DEVELOPMENT REVIEW BOARD
SUPPLEMENTAL SUBMITTAL

PROJECT NO. PR-2021-004038
Application No. SD-2021-00098

A Lot Consolidation Replat, combining Lots 3, 4, 5, & 6, Block 8, Broadacres Subdivision at the northwest corner of Menaul & Pennsylvania

June 4TH, 2021

Design: RJM	Proj: 19.106
Draw: JMM	Dwg: 19-106.dwg
Check: RJM	Tab: C4.0-UP
Scale: 1" = 20'	
Date: 02.05.2021	
Sheet: UTILITY PLAN	
Sheet No.: C-4.0

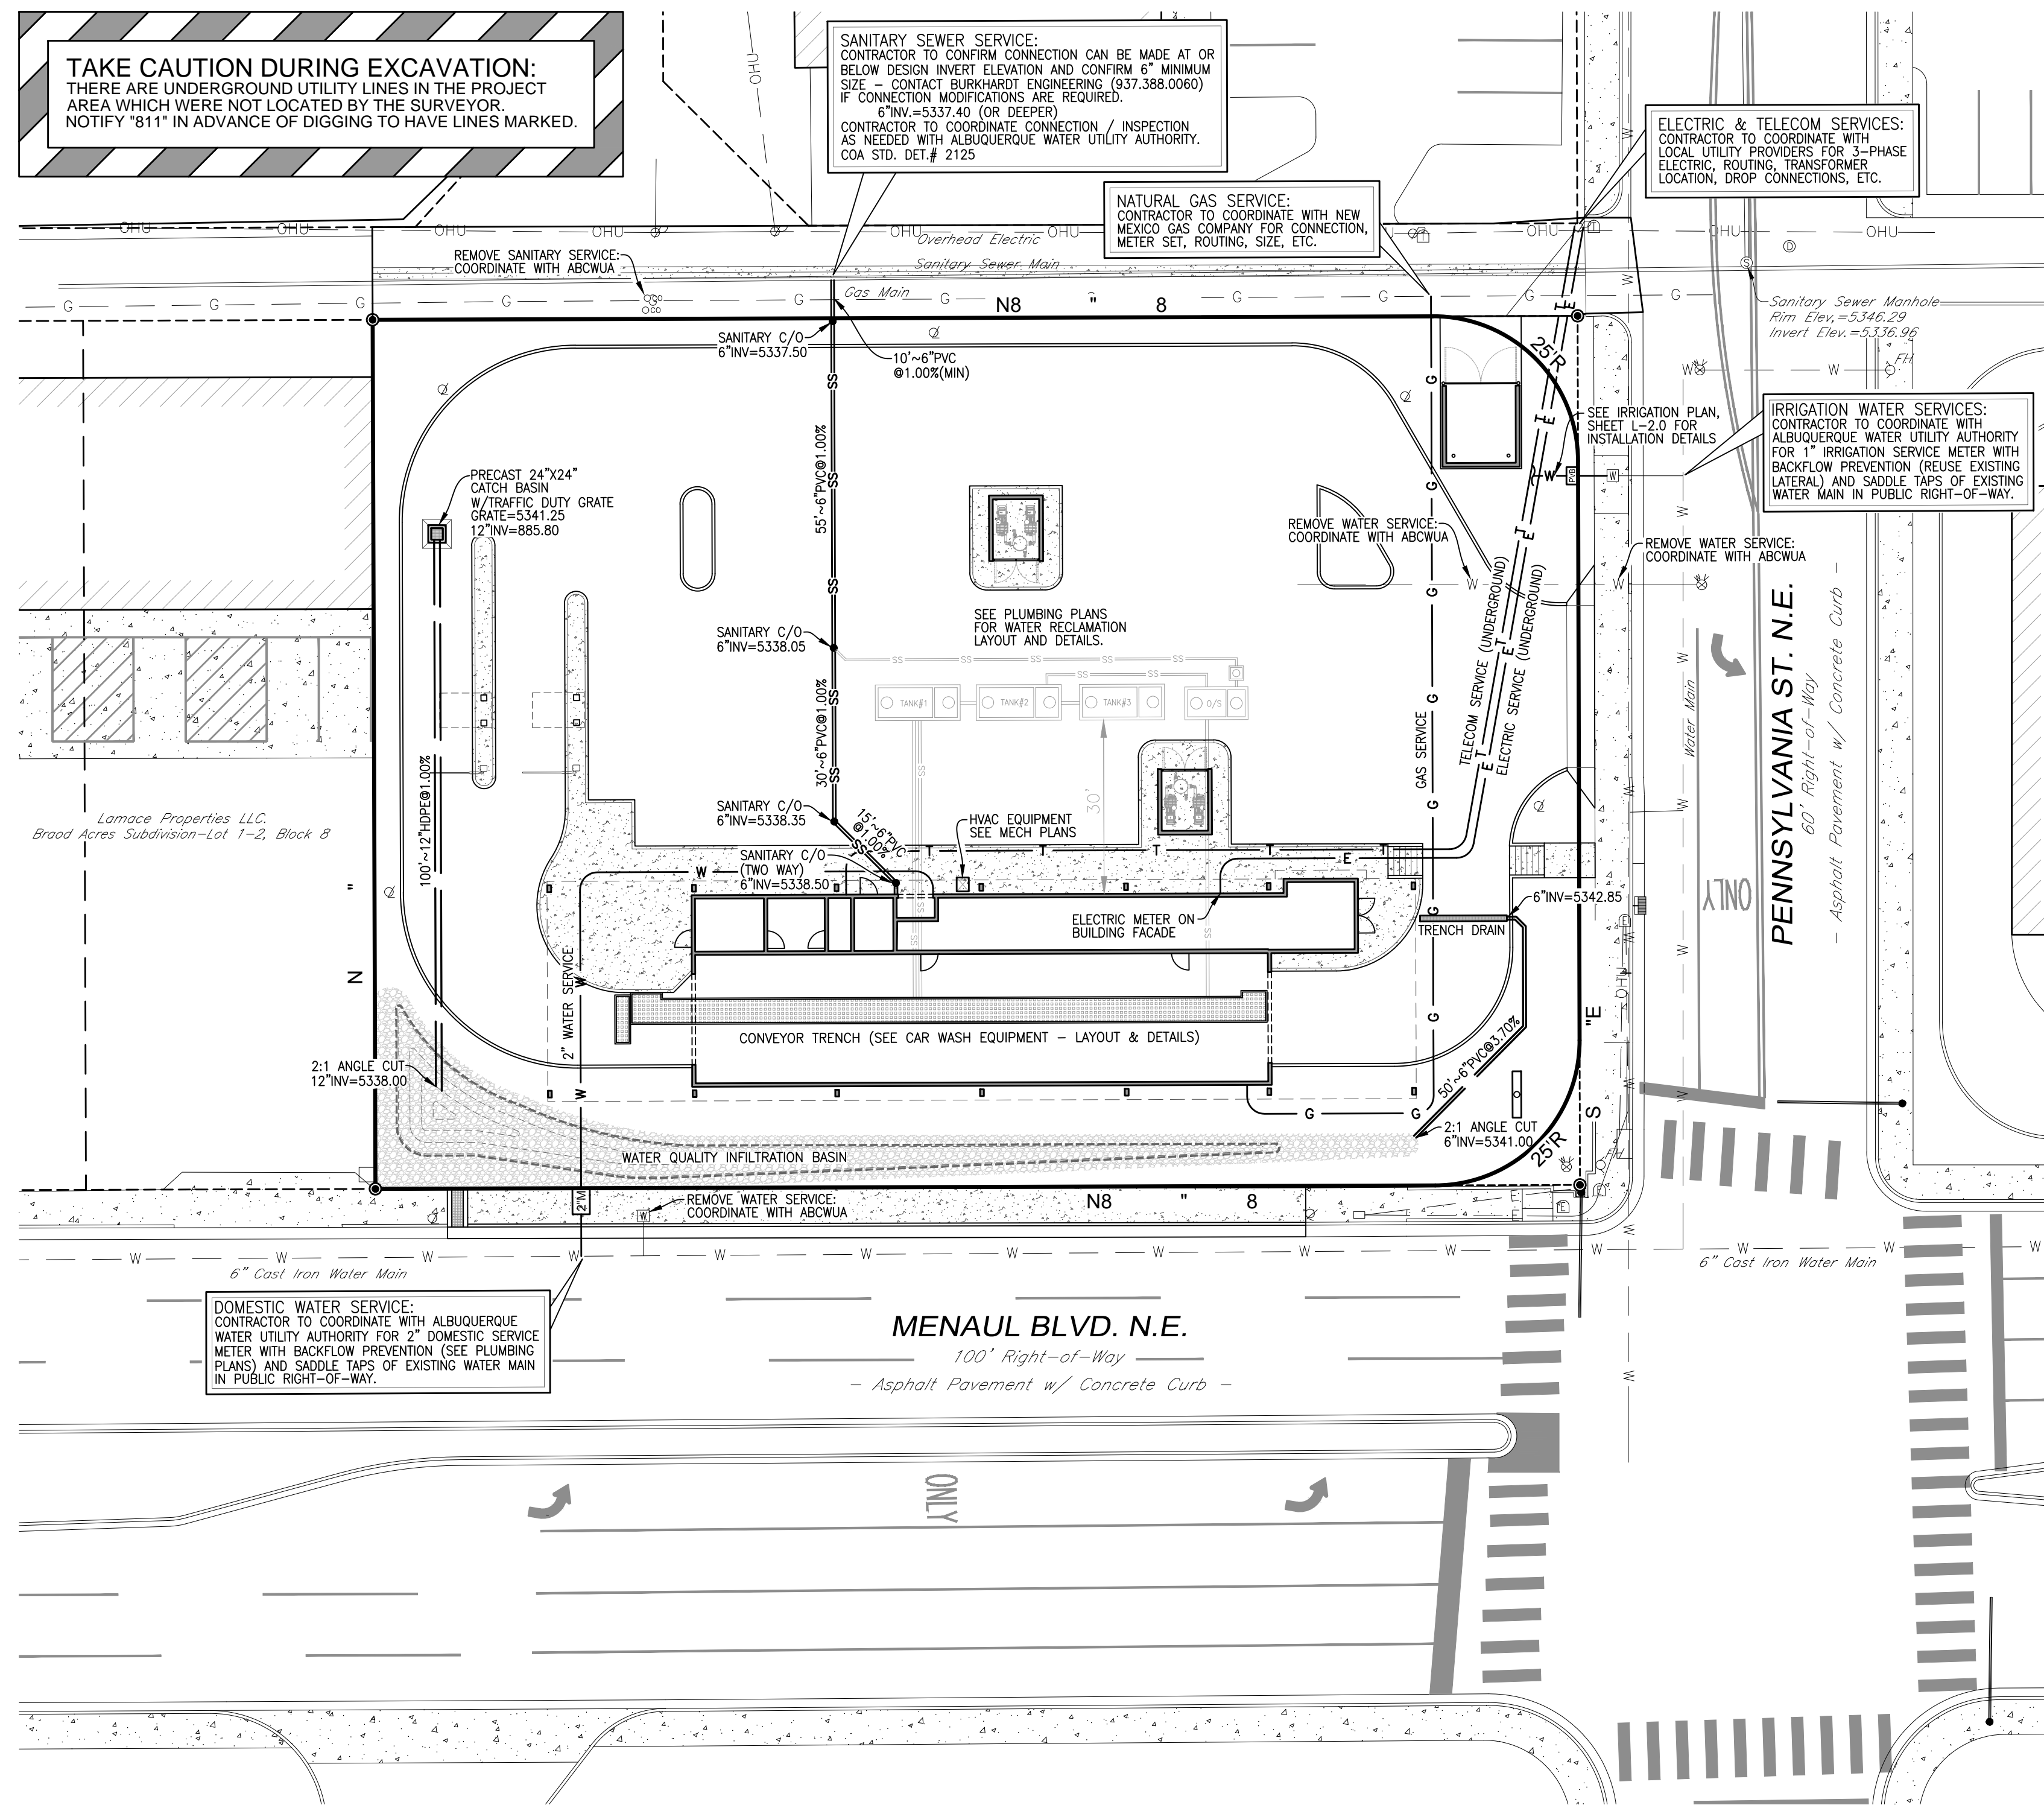
1. Utility Plan:
 - a. Please provide a utility plan that shows the requested tap location, sewer service location, and removal the unused service lines.
Response: See sheet C-4.0 (Utility Plan) for water and sewer service information. (reduced 8.5"x11" attached for reference)
2. Infrastructure List:
 - a. Please add the removal of the unused water and sewer services to the infrastructure list.
Response: Infrastructure List updated to include removal of unused water and sewer services.
3. Availability Statement #210211 has been issued and provides the conditions for service.
Correct, Water and Sanitary Sewer Availability Statement #210211, dated March 25th, 2021 is on file and we intend to accommodate in service design and advise the developer to do so during construction, etc.
